ADDENDUM #2 TO CONTRACT DOCUMENTS

INVITATION TO BID (ITB) # 20-08-402
MEDIAN ENTRY WELCOME SIGNAGE

Addendum Date: September 1, 2020

SIGN DIMENSIONS

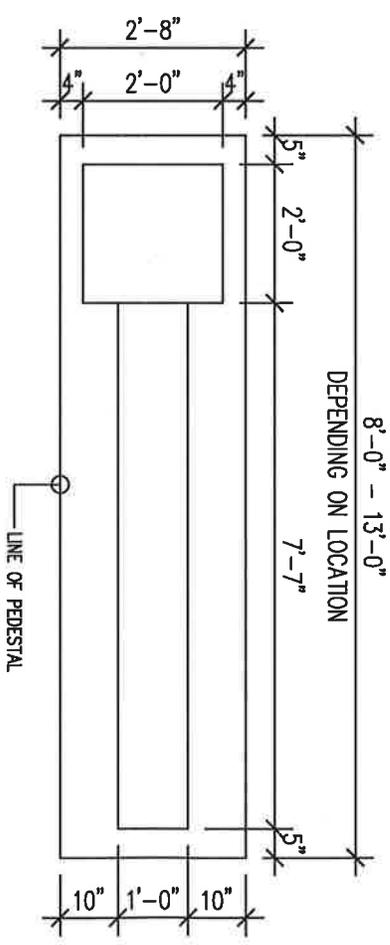
QUESTION(S)	RESPONSE(S)
The specs show the base being 8' - 13' but then the specs call for 5" in from the edges of the pedestal. The dimensions add up to 125" so the pedestal base would be 135" based on these drawings. Are the signs going to all scale to keep the same 5" from each side and scale the base proportionately?	For 8' to 10' signs bases shall be 3". We will review and finalize after review of shop drawings.
